CAPE COD COMMISSION

RE: Development of Regional Impact Hardship Exemption
Cape Cod Commission Act, Section 23

Project: Excel Switching Corp Corporate Facilities
Perseverance Way and Gonsalves Avenue
Hyannis, MA

DECISION OF THE CAPE COD COMMISSION

Exhibit A-2

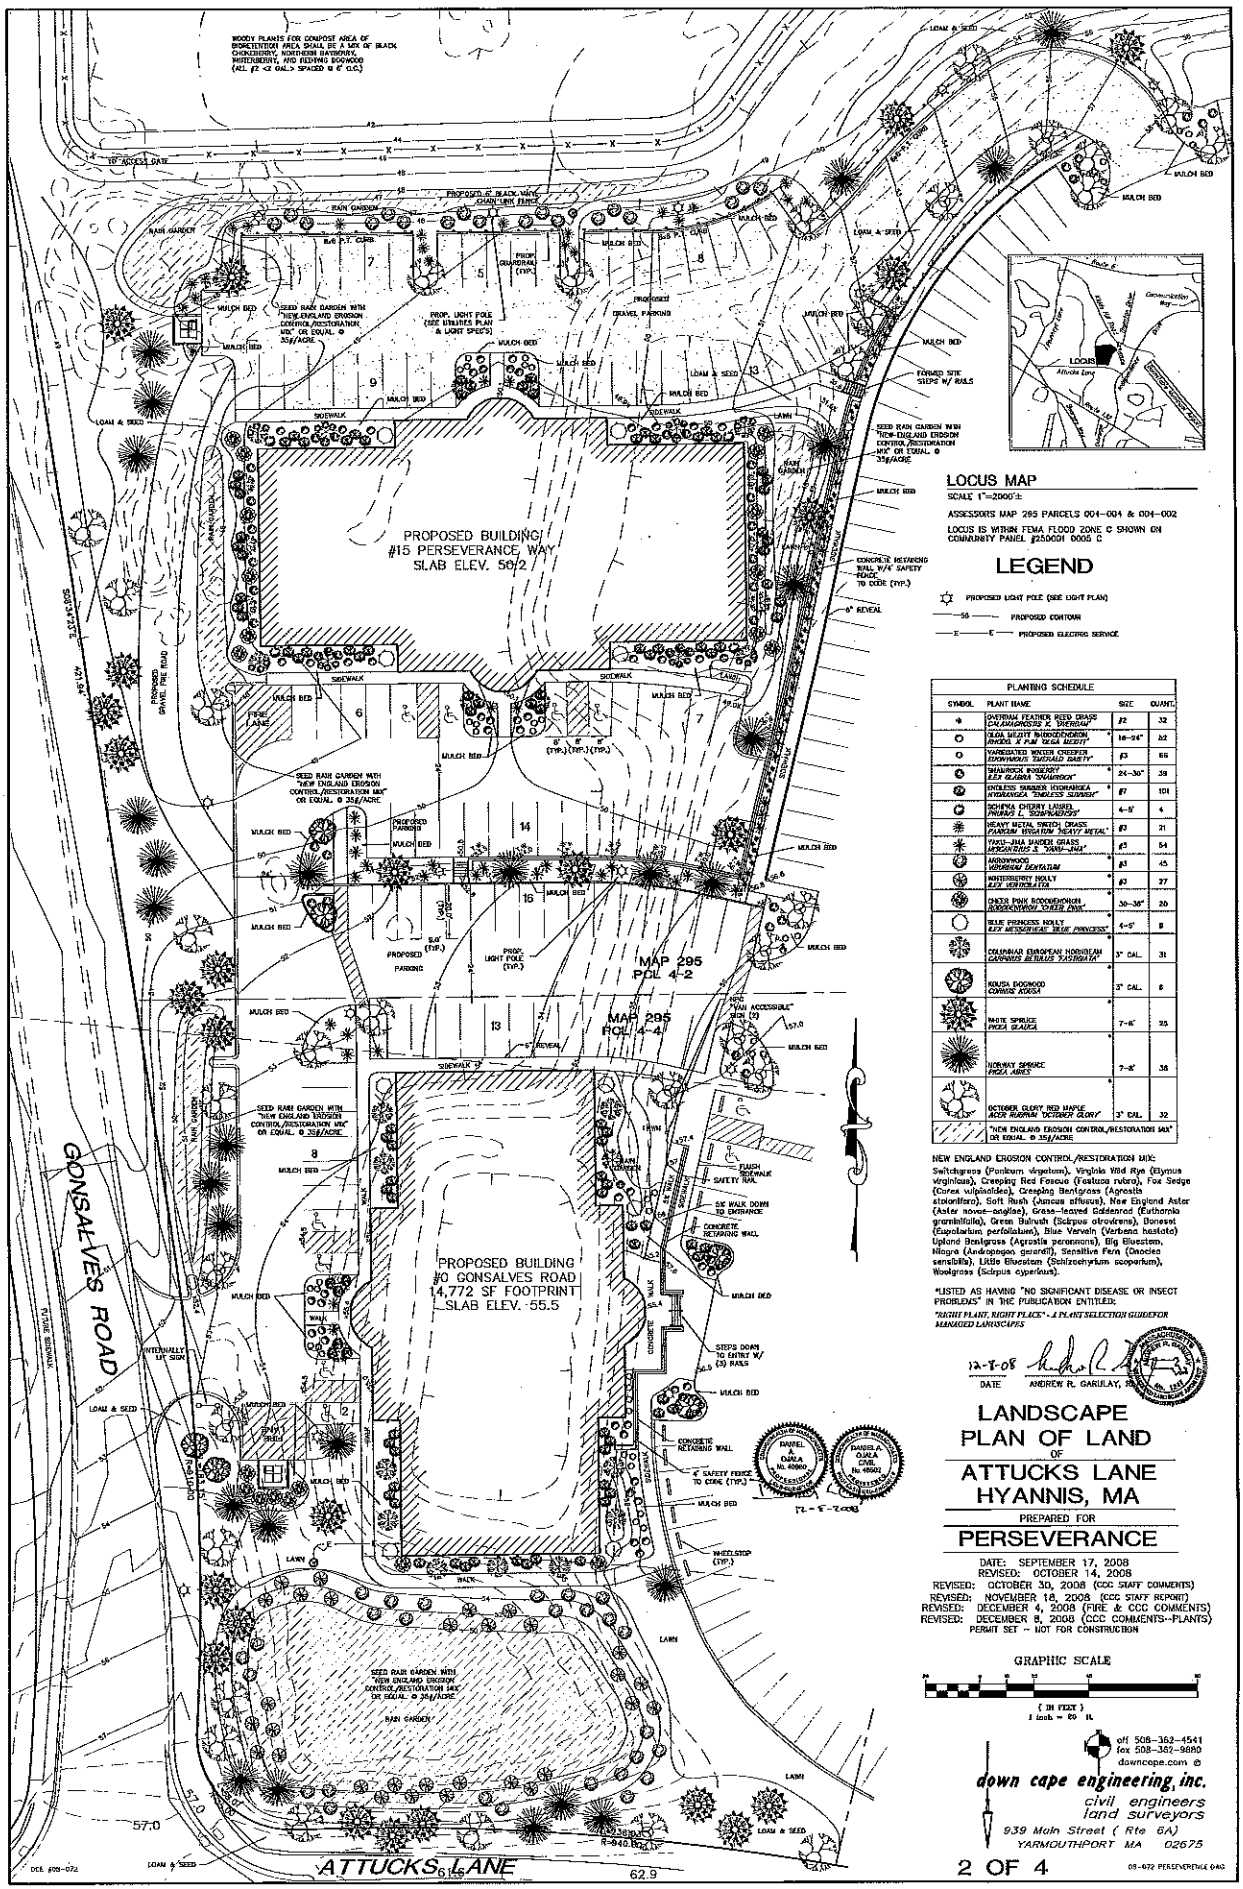
CCC3. The landscape shall be constructed in accordance with the plans, "Landscape Plan of Land", revision dated December 8, 2008 and "Bioretention Woody Planting Sketch Plan" dated December 4, 2008 with the following exceptions. The bioretention plan will be modified to show a substitute species for Bayberry. The Landscape Plan will be modified to show shade trees planted along the parking strip southeast of Building 1 and the rain gardens along Gonsalves Road augmented with drought and pest tolerant shrubs. The drainage swale at the southeast corner of Building 1 will be stabilized with more appropriate plantings or seed mix. The modified plans will be submitted prior to the issuance of any building permit. Prior to the start of landscape construction for Building 1, the Applicant shall submit for the Commission's review and approval, specifications on loam depths for all seeded and sodded areas, the specific sod and/or grass seed mixes to be used, the male pollinators proposed for the Blue Princess and Winterberry Hollies, and planting installation details. The soil profile for the drainage basins will be as directed by the Commission's hydrologist.

SWC2. The location of the solid waste dumpster or dumpsters on the site shall be consistent with Sheet 2 of 4, *Landscape Plan of Land*, revised December 8, 2008, by Down Cape Engineering, Inc., or shall be positioned in such alternative manner as to ensure the solid waste dumpster(s) is well screened from general viewing areas. Prior to issuance of the Final Certificate of Compliance from the Commission for Building 1, a site visit must be conducted by Commission staff to verify conformance with the requirements of Condition SWC2. Until the Commission staff issues a written approval based on the site visit, the Final Certificate of Compliance shall not be issued.

BIORETENTION WOODY PLANTING SKETCH PLAN

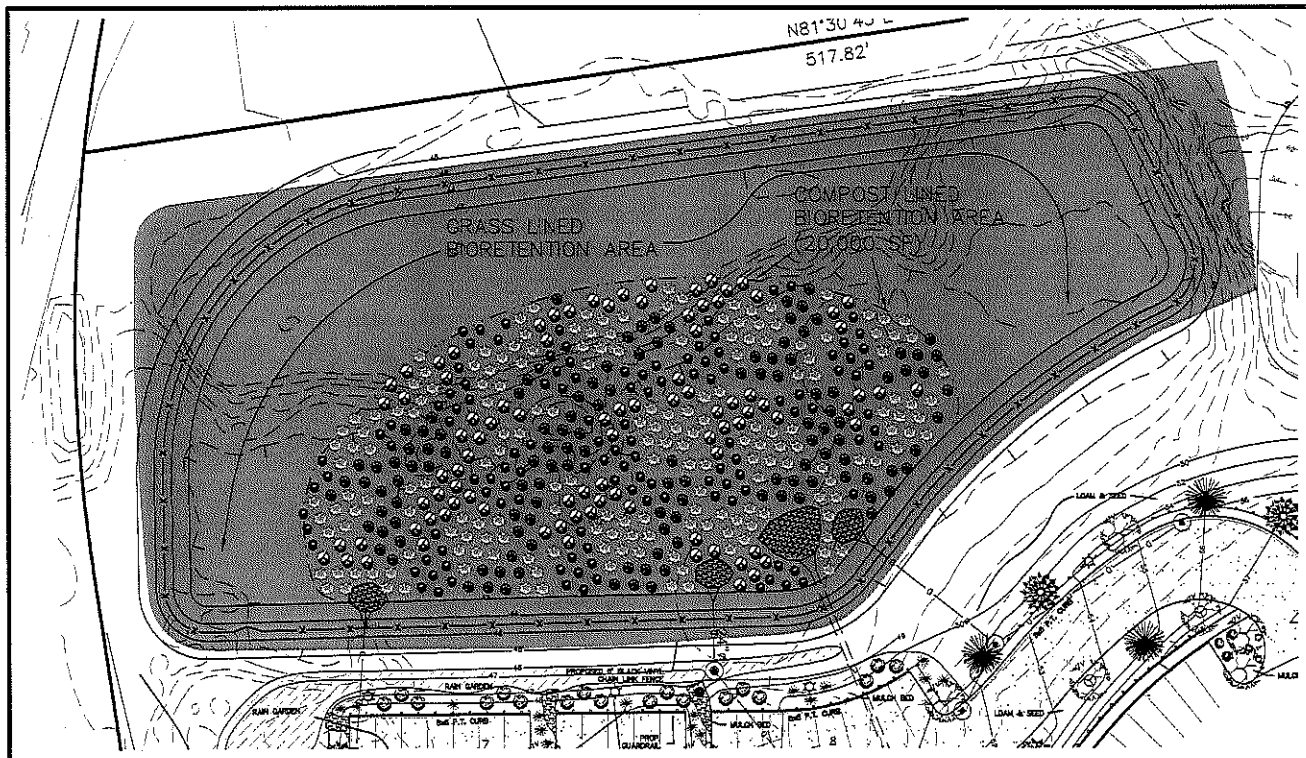
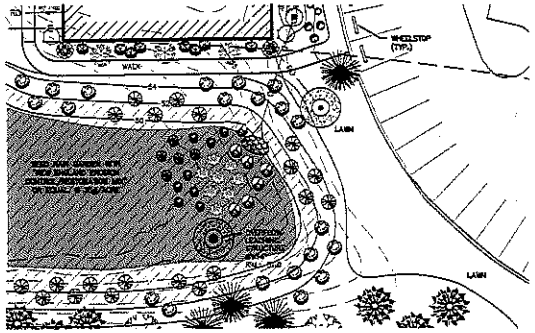
A diversified mix of drought-, moisture- & pest-tolerant plantings should be added to the lower reaches of all rain gardens and supported by a well-drained soil mix. The banks of the rain gardens on the west side of the buildings should also be planted. The bayberry proposed for the retention basins should be removed because of its ability to add nitrogen to the soil.

WRC1. Prior to issuance of the Preliminary Certificate of Compliance by the Commission for Building 1, the Applicant shall submit for Commission staff review and approval a landscaping plan that adds a diversified mix of drought-, moisture- & pest-tolerant plantings to a) the lower reaches of all rain gardens, supported by well-drained soil mix; and b) the banks of the rain gardens on the west side of the buildings.

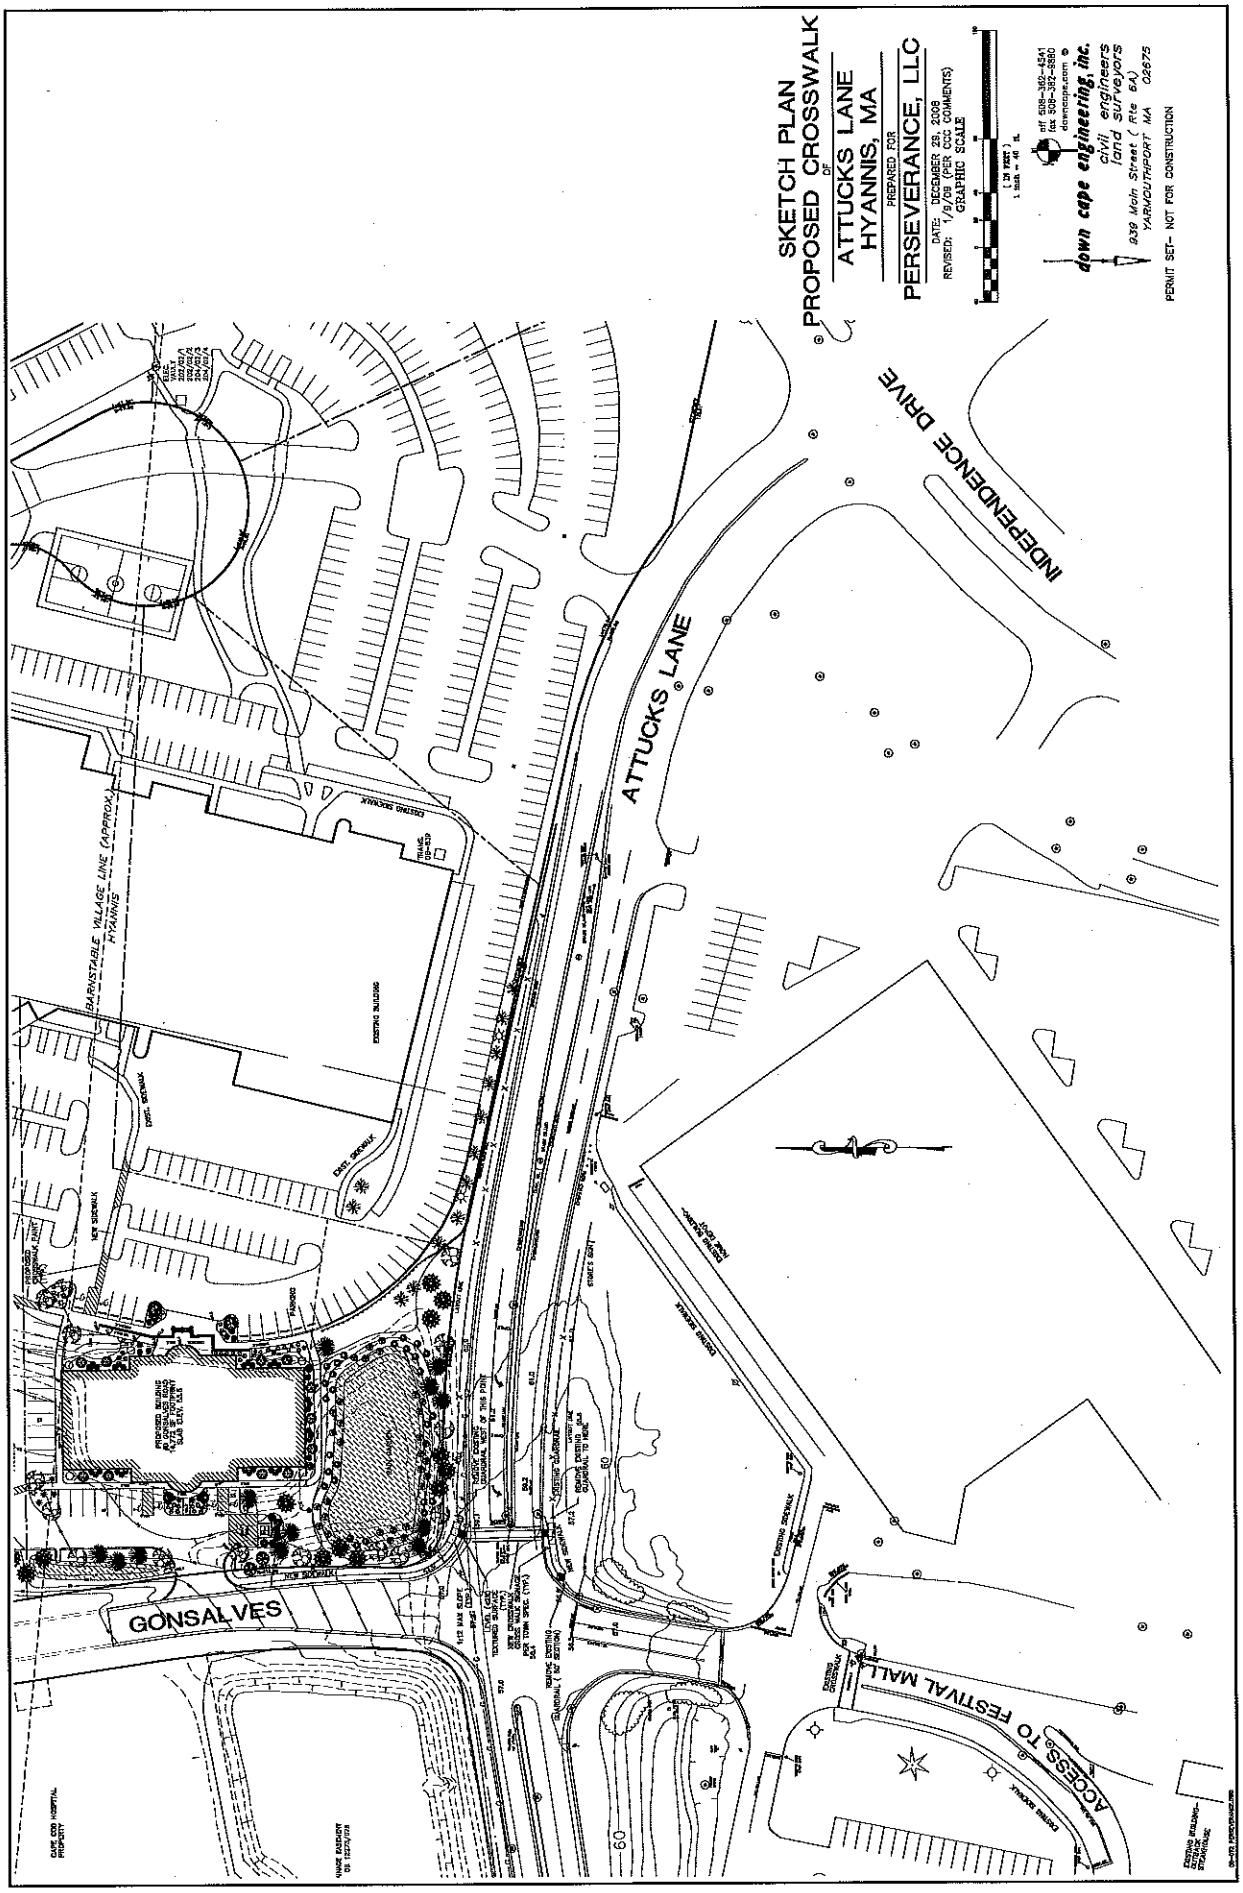
Ms. Seldin suggested discussing sidewalks. Mr. Ojala explained the revised sidewalk plan. He stated the principal concern seemed to be allowing pedestrians to get to the lunch type destinations. He said there were already existing sidewalks and interconnections, which were in simple line of sights. He noted the town engineer said people tend to look for crosswalks at intersections. Mr. Ojala said his preference was a simple crosswalk with signage and striping, as a signal light is expensive. Mr. Ojala also noted that there is already a light footpath in the area of the proposed crosswalk.

Mr. Crowell made the motion to accept the new sidewalk plan that included revisions made today. Mr. Putnam seconded the motion. It passed unanimously. Ms. Seldin explained that they are approving the sidewalk plan as explained by Mr. Ojala with the approval of the town and Mr. Cannon.

TF6. The Applicant has agreed to design and construct a sidewalk on Gonsalves Road and a crosswalk on Attucks Lane at the Festival Mall access driveway. These proposed improvements are shown on the site plan titled Sketch Plan Proposed Crosswalk revised January 9, 2009 by Down Cape Engineering, Inc.

DRAWN DKS
CHECKED DKS
SCALE 1/8"=1'-0"
DATE DEC. 15, 2008
TITLE
CONCEPT ELEVATIONS
SHEET
C17

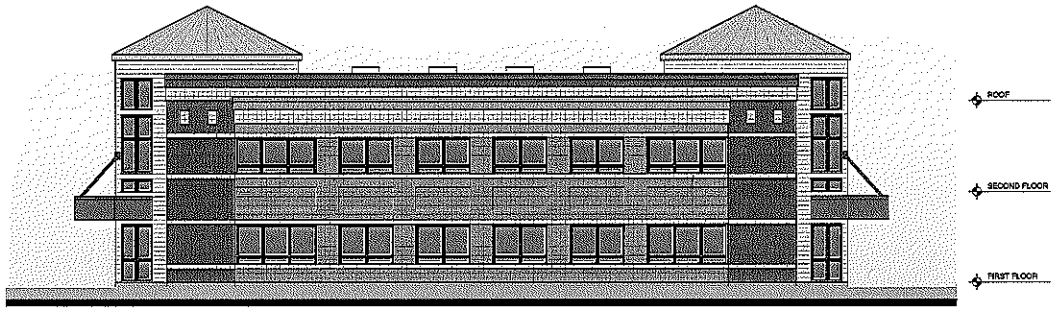
Mr. Dascombe stated there were three areas of concern with the plan - the visibility of rooftop equipment, materials, and the entry feature. Mr. Dascombe clarified that the "finalists" are plans C-17 and C-18; the only difference being the height of the center entranceway. Ms. Taylor stated that the conical towers in the plans are not very "Cape Cod" and that she likes C-13 better. Ms. Buntich said leaving the entryway aside, the town has no problems with plan C-18. She also stated the town prefers the entryway on C-13 as it has a 4 sided 'cap'. The rounded proposals (C-17) aren't preferred. Mr. Sanford stated that the applicant prefers C-17 and dislikes C-13. Mr. Bornstein stated that the buildings are large enough and he doesn't like the white columns in the plan or columns in general. Mr. Blanton stated he was in support of the roundness of plan C-17. He doesn't want the 'right angle' big buildings that look like architecturally decorated warehouses. Mr. Putnam agreed in terms of the roundness of the structure. He said that deciding

Mr. Putnam made a motion to approve plan C-17. Mr. Blanton seconded the motion. Ms. Taylor voted in opposition. The motion passed with three members voting in agreement.

CCC1. The project shall be constructed in accordance with the plans titled "Concept Elevations Sheet C17" and dated December 15, 2008 (revised December 16, 2008). Building 1 shall be constructed first to screen the associated parking from views from Attucks Lane.

REVISIONS
12/16/08
ROOF OF ENTRY FEATURE ADJUSTED AND MEDALLIONS ADDED

SHEET
C19

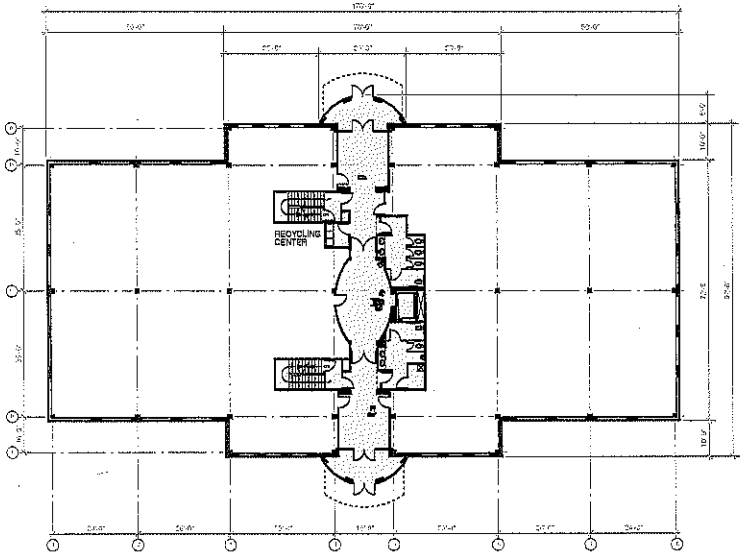
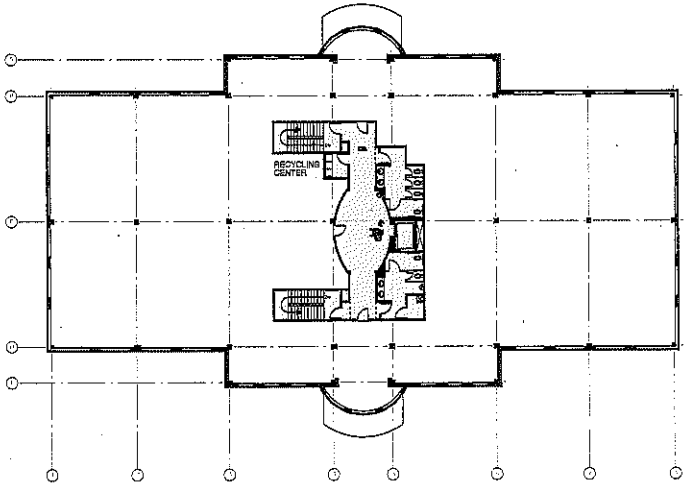
SWF1. MPS 4.2.1.3 requires DRIs to provide *"[s]uitable locations for the collection, storage, and removal of recyclable materials..."* Sheet C19, *Floor Plans*, dated January 13, 2009 drawn by Douglas Sanford Associates Inc. shows the anticipated location of recycling containers for paper, cardboard and plastic materials. Also, Sheet 2 of 4, *Landscape Plan of Land*, dated September 17, 2008, revised December 8, 2008, drawn by Down Cape Engineering, Inc. indicates that the solid waste dumpsters are well screened from general viewing areas.

SWC1. The location of recycling containers for paper, cardboard and plastics inside the buildings shall be consistent with Sheet C19, *Floor Plans*, dated January 13, 2009 drawn by Douglas Sanford Associates Inc. Prior to issuance of the Final Certificate of Compliance from the Commission for Building 1, a site visit must be conducted by Commission staff to verify conformance with the requirements of Condition SWC1. Until the Commission staff issues a written approval based on the site visit, the Final Certificate of Compliance shall not be issued.
